## 10.0 Steam and Power Conversion System

The information in this section of the reference ABWR DCD, including all subsections, tables and figures, is incorporated by reference with the following departures and supplements.

Figure 10.1-1 Reference Steam and Power Conversion System

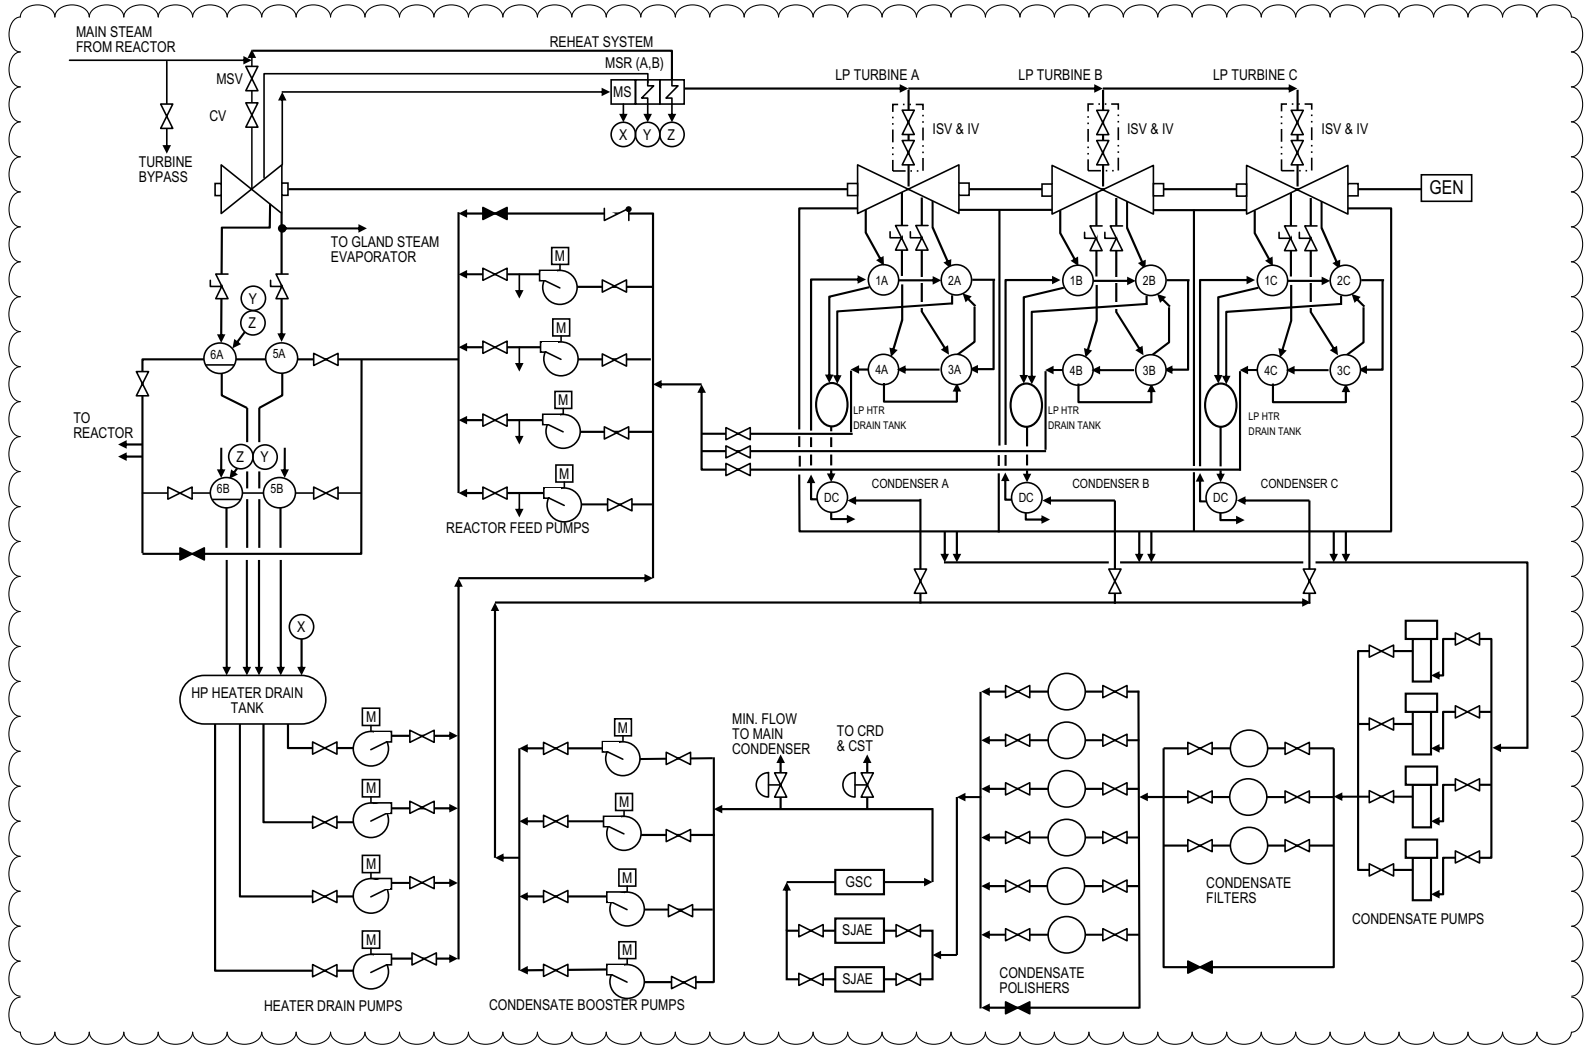
STP DEP 9.2-3 (Figure 10.1-1)

STP DEP 10.1-2 (Figure 10.1-1)

STP DEP 10.2-1 (Table 10.1-1, Figure 10.1-1)

*Steam, generated in the reactor, is supplied to the high-pressure turbine and the second stage reheaters of the steam moisture separators/reheaters. Extraction steam from the high-pressure turbine is supplied to the first stage reheaters of the moisture separators/reheaters. Steam leaving the high-pressure turbine passes through a combined moisture separator/reheater prior to entering the low pressure turbines. The moisture separator drains, steam reheater drains, and the drains from the two high pressure feedwater heaters are pumped back to the reactor feedwater pump suction by the heater drain pumps. The low pressure feedwater heater drains are cascaded to the condenser.*

*Steam exhausted from the low-pressure turbines is condensed and deaerated in the condenser. The condensate pumps take suction from the condenser hotwell and deliver the condensate through the filters and demineralizers, gland steam condenser, steam jet air ejector condensers, ~~offgas recombiner condensers~~, and to the suction of the condensate booster pumps. The condensate booster pumps discharge condensate through the low-pressure feedwater heaters to the reactor feed pumps. The reactor feed pumps discharge through the high pressure feedwater heaters to the reactor.*
